X 86.106-26

MODELS 181 XP/281 XP

NEW SHORT-CIRCUIT SWITCH - BETTER LEADS (w. 619)

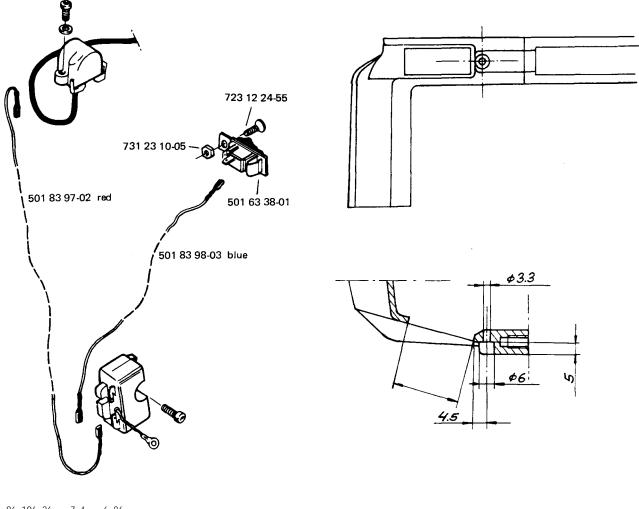
Switch Ref. No, 501 63 38-01 (154) has a terminal with the width 4.8 mm and the switch Ref. No. 501 81 52-01 has a terminal with the width 6.3 mm. The spade terminals on the lead have the corresponding width, Ref. No. 501 83 98-03 and the lead 501 83 98-02. To be able to mount the switch Ref. No. 501 63 38-01 on older saws, the screw, nut and new lead must be ordered separately to the stop switch.

Also two holes ø 6 mm and ø 3.3 mm must be drilled in the crankcase, according to the ill. See below.

New Ref. No.	Denomination	Excluded Ref. No.	<u>Remark</u>
501 63 38-01 5	Short-circuit switch	501 81 52-01	Remains as a spare part
723 12 24-55	Screw		
731 23 10-05	Nut		
501 83 98-03 (Grounding lead-module	501 83 98-02	Changing from black to blue colour, -02 remains as a spare part

Lead module-ignition coil Ref. No. 501 83 97-02 is only changing colour, from yellow to red.
